SUBJECT: PLANS AND PROPOSAL ADDENDUMS

PROJECT: C 72-8-143

CONTROL: 0072-08-143

COUNTY: BEXAR

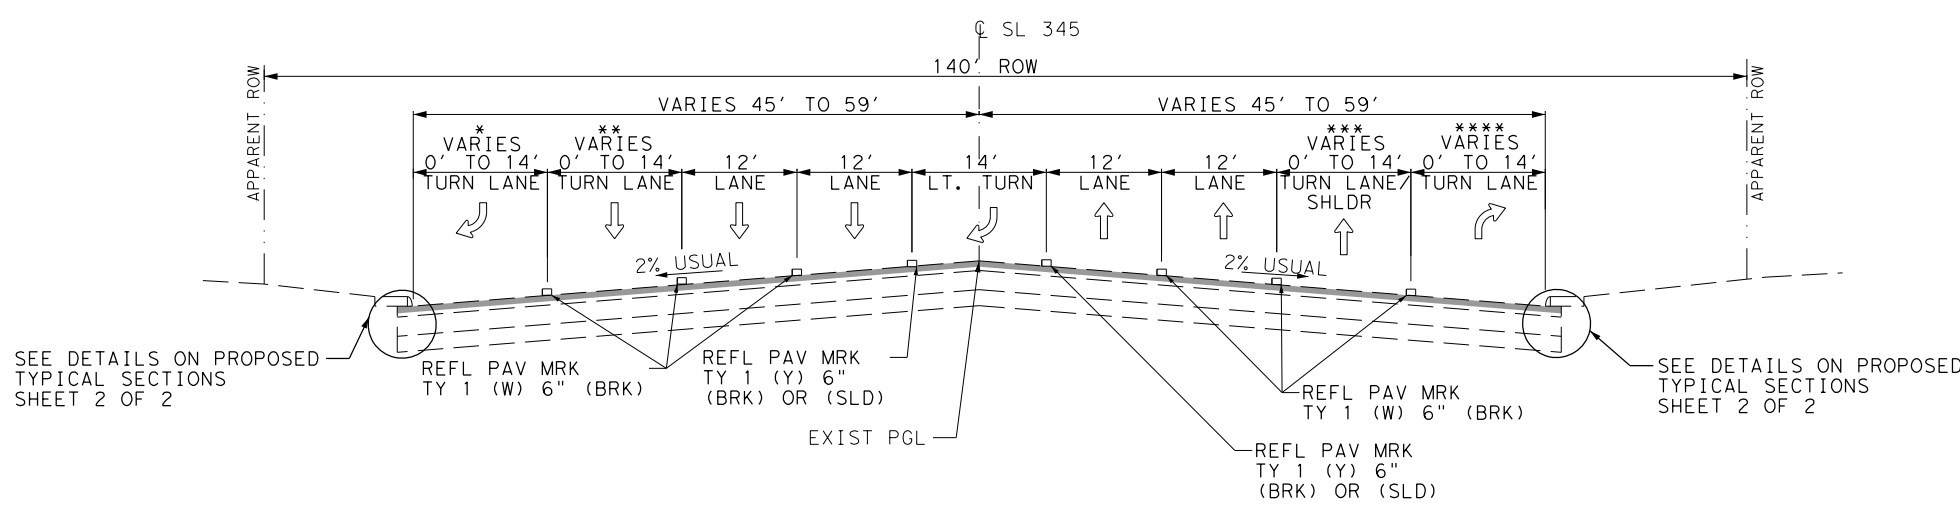
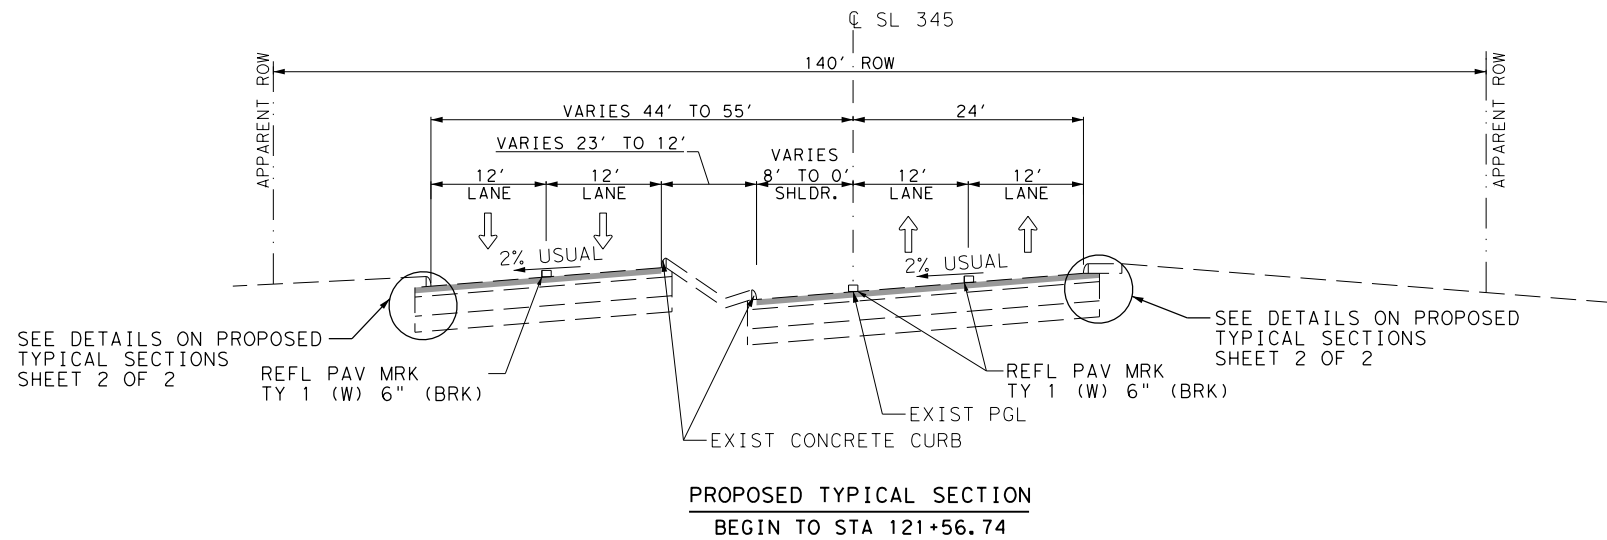
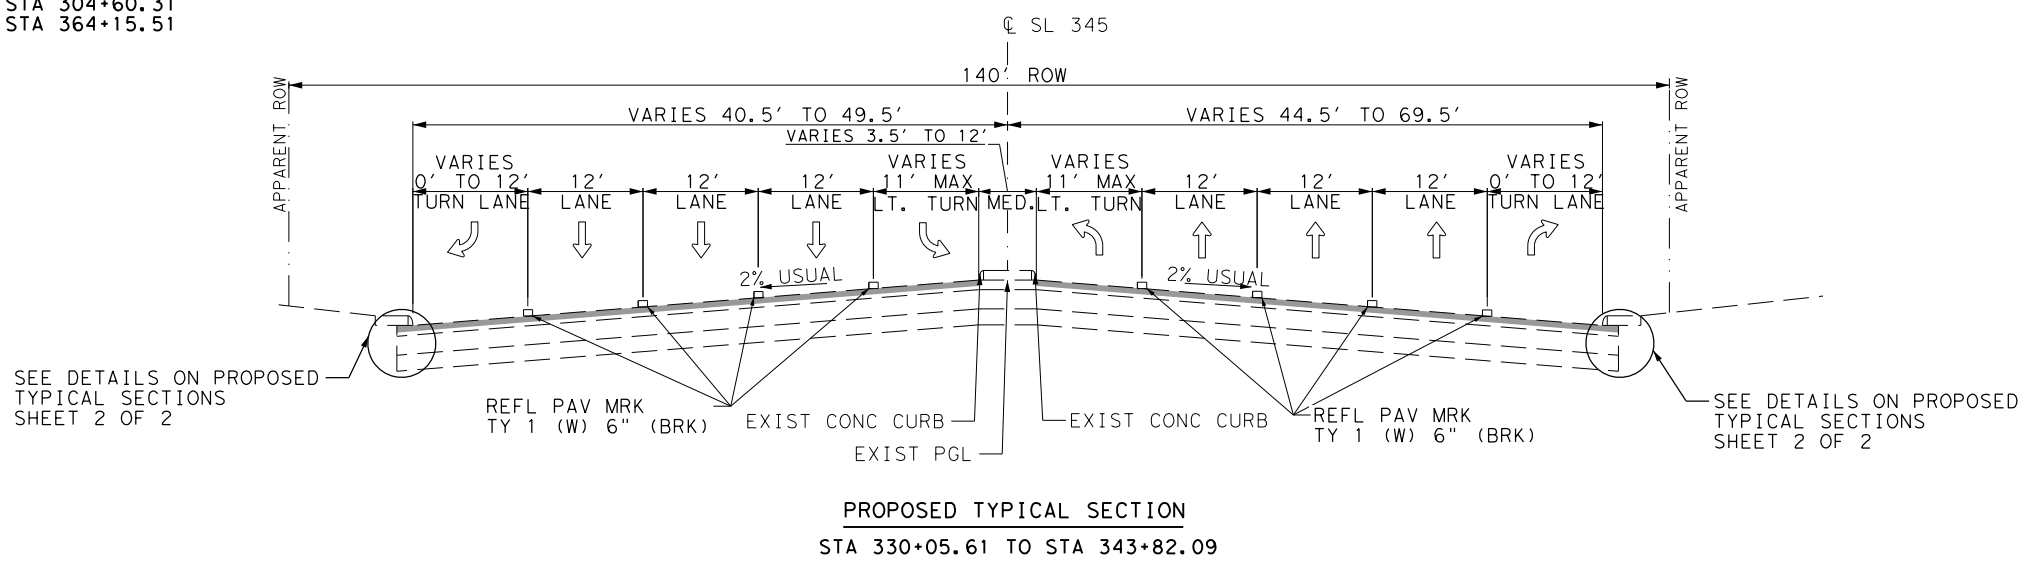
SHEETS 6-7: REVISED NOTE AND PAVEMENT DETAILS TO REMOVE 2" AND 4" MILL AND INLAY

**PLANING END TREATMENTS**  
NOT TO SCALE

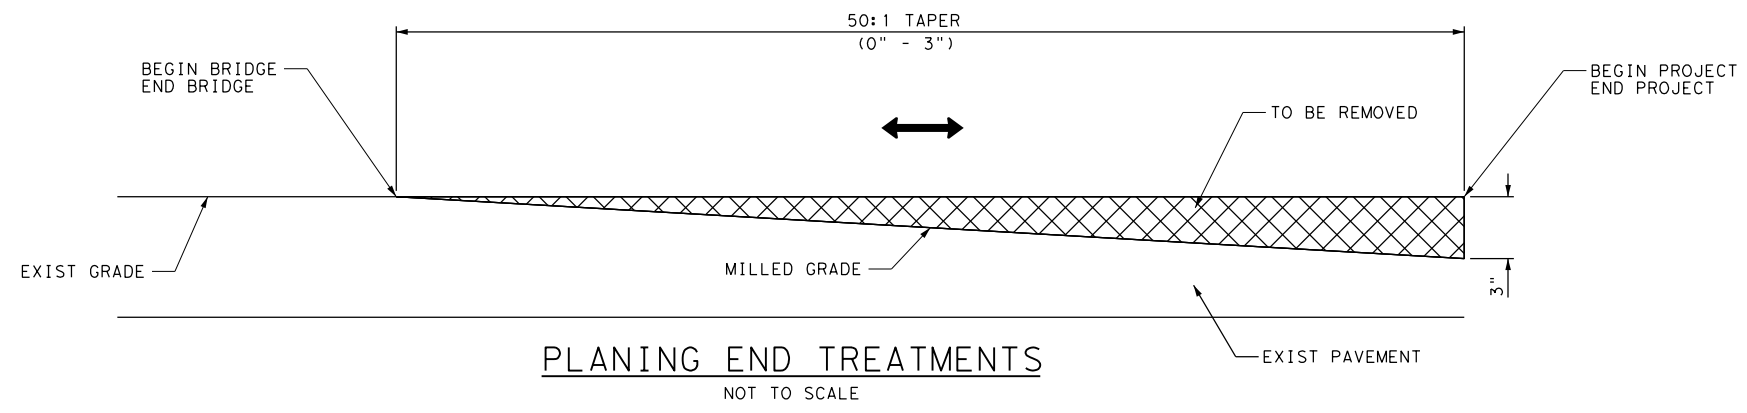
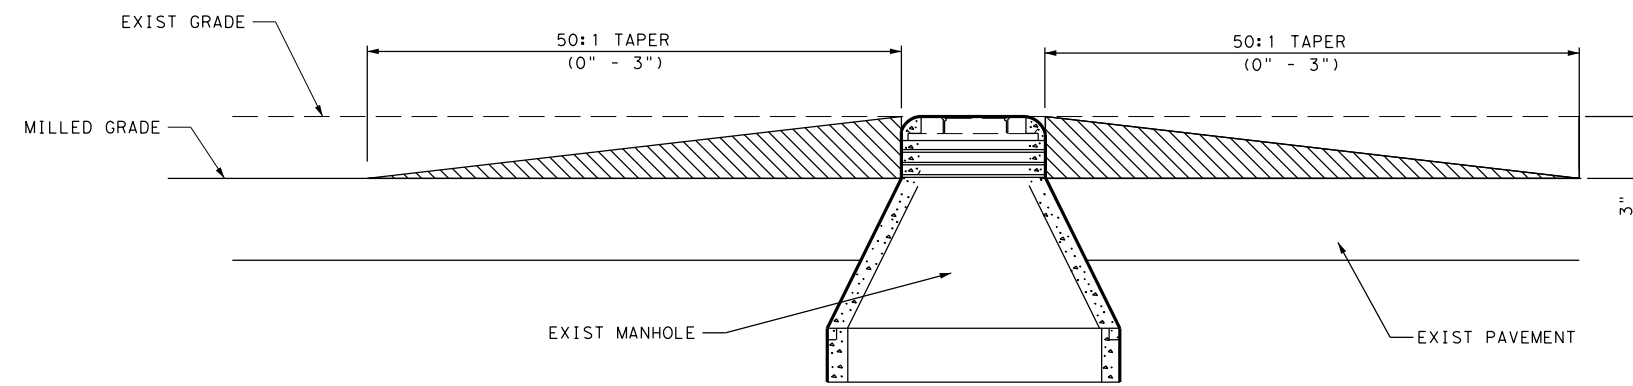
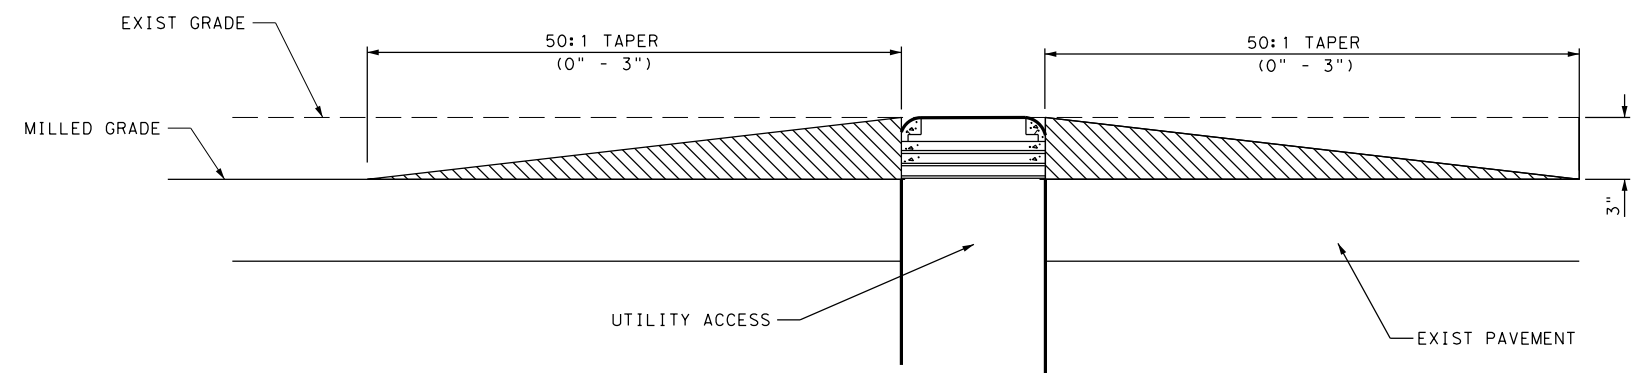
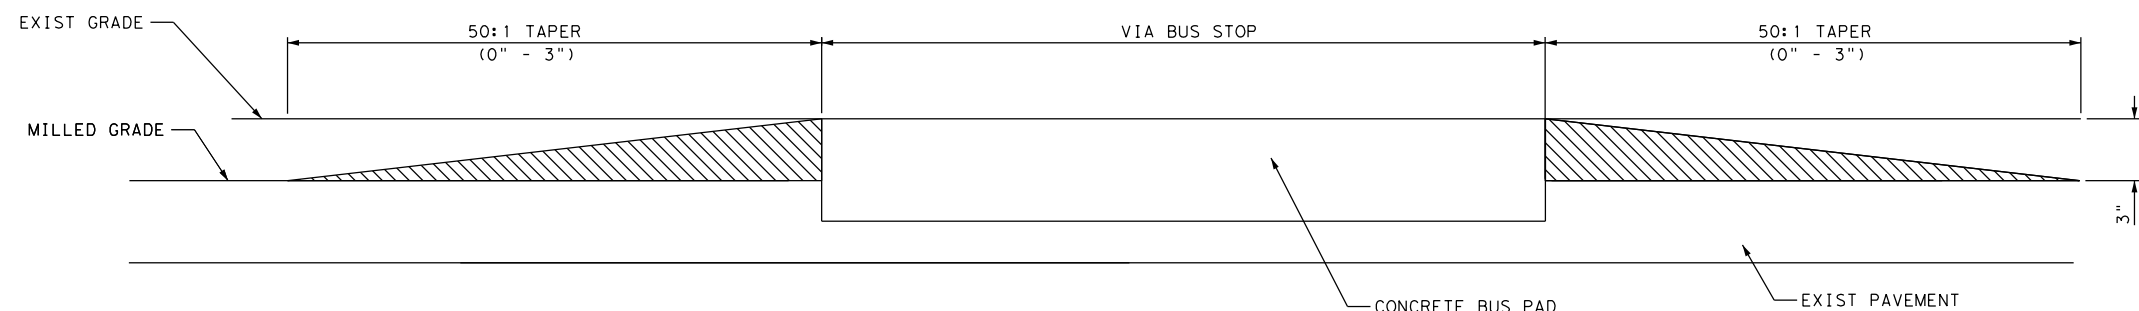
SHEET 28: REVISED DIMENSIONS TO REMOVE 2" AND 4" MILL AND INLAY TRANSITION

**FLEXIBLE PAVEMENT STRUCTURE REPAIR 10"  
TYPICAL SECTION**

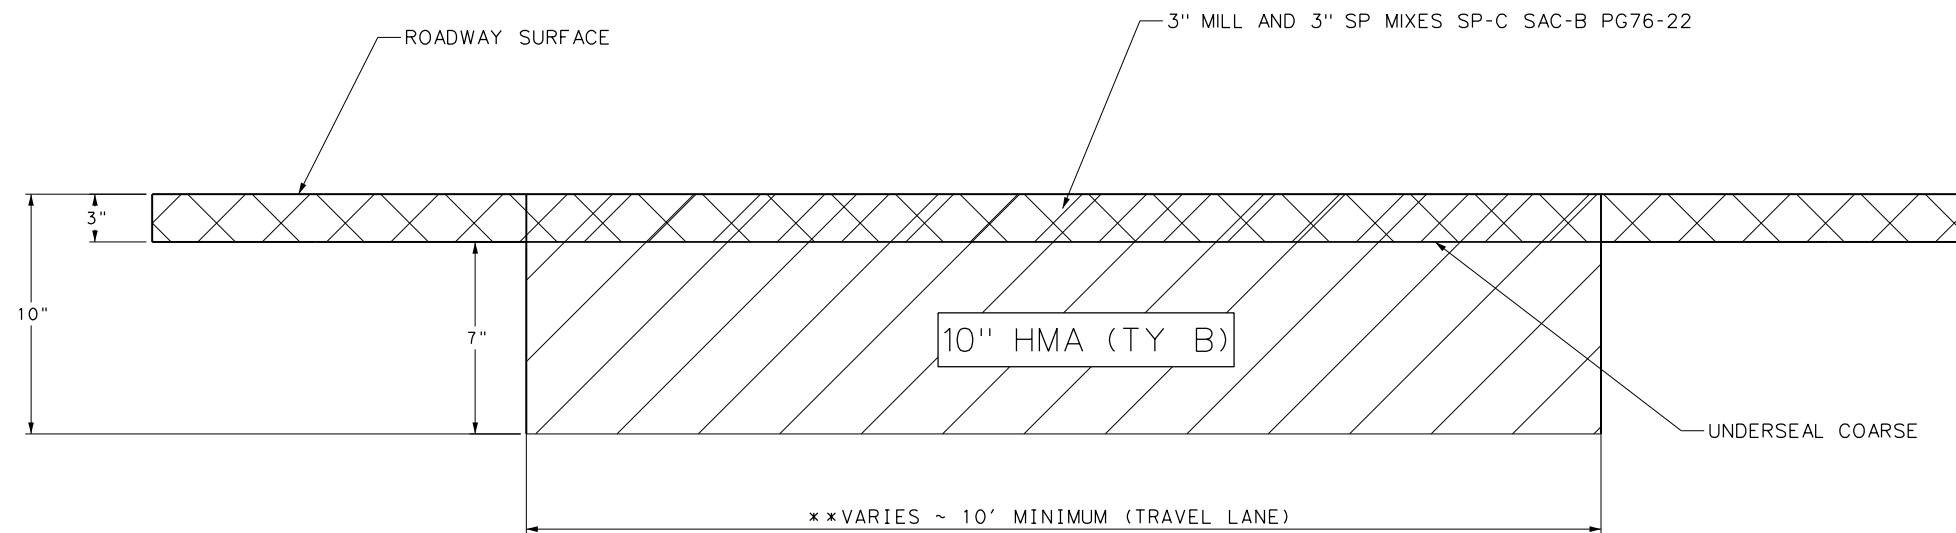
SHEET 68: REVISED FLEXIBLE PAVEMENT REPAIR DETAIL TO REFLECT 3" MILL AND INLAY

**PLANING END TREATMENTS**  
NOT TO SCALE

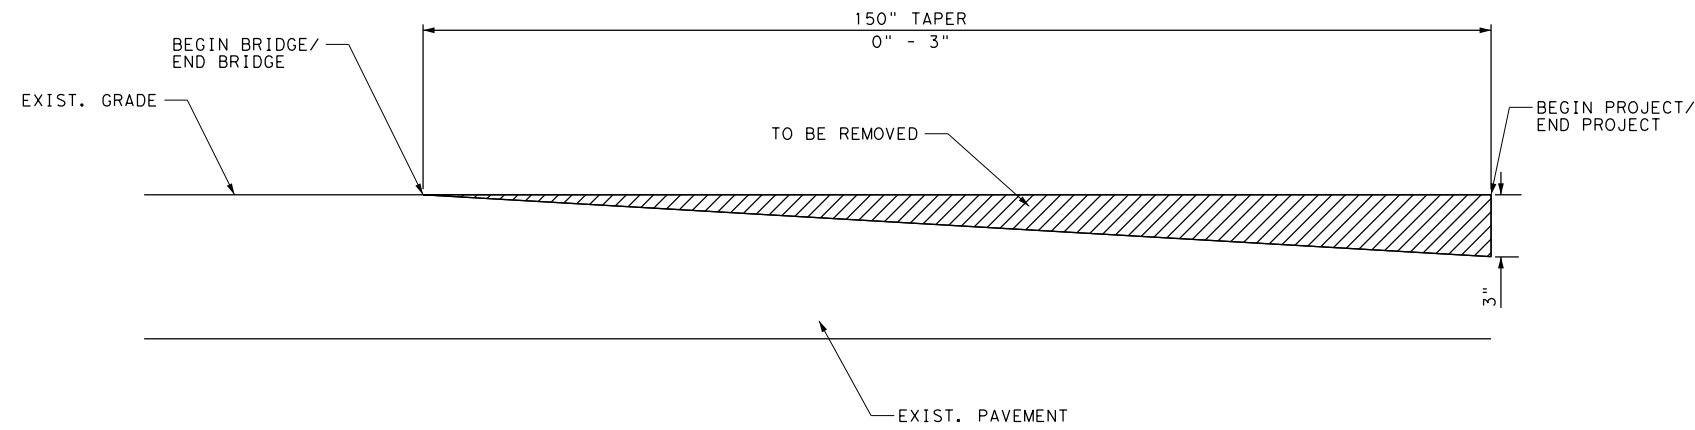
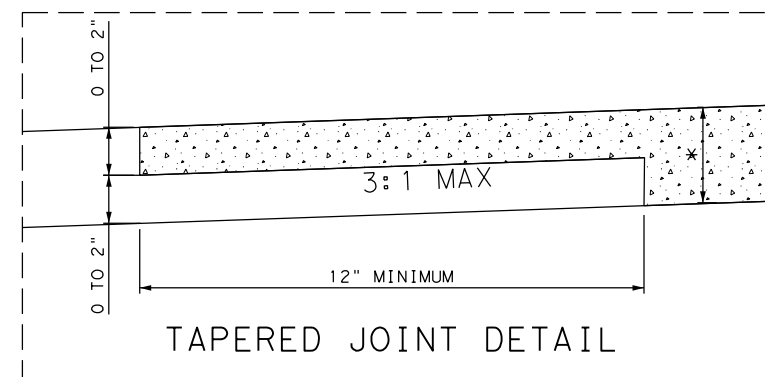
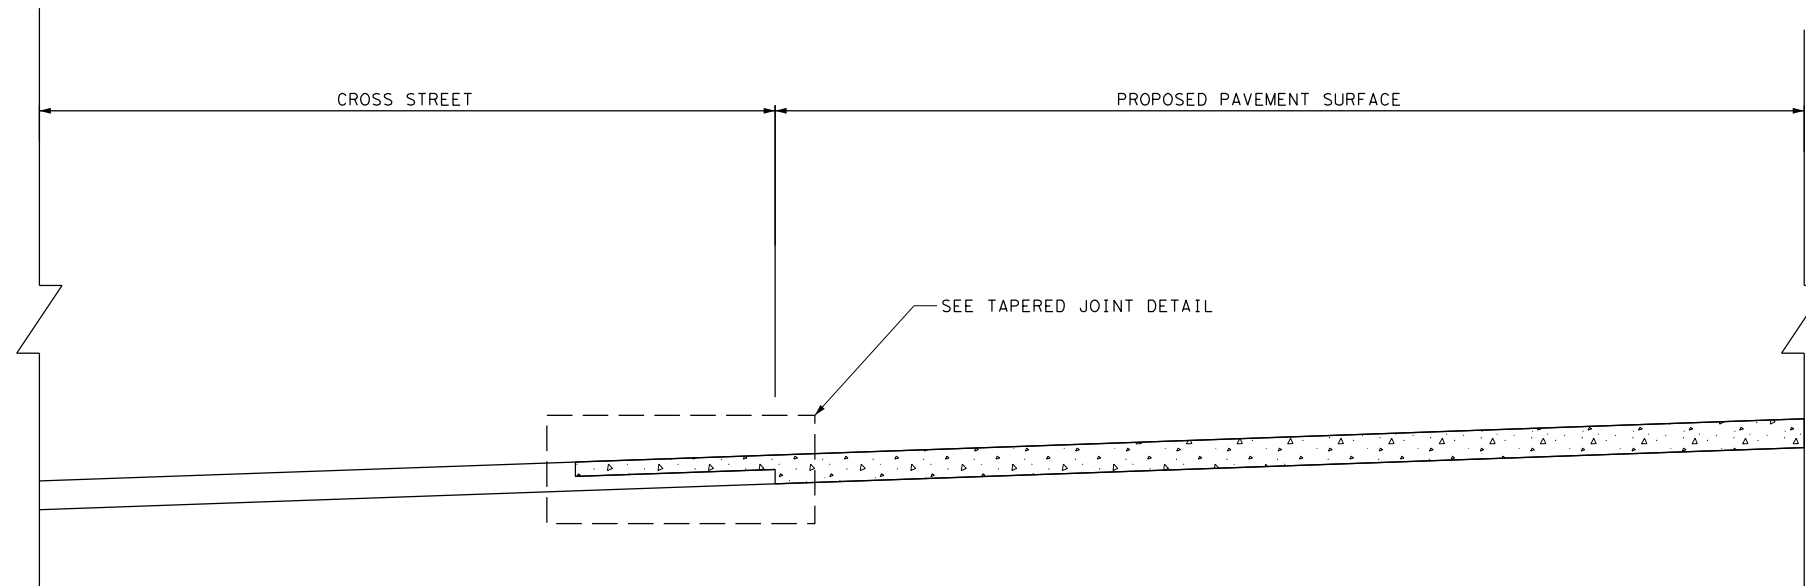
SHEET 69: REVISED PLANNING END TREATMENTS DETAIL FOR 3" MILL AND INLAY
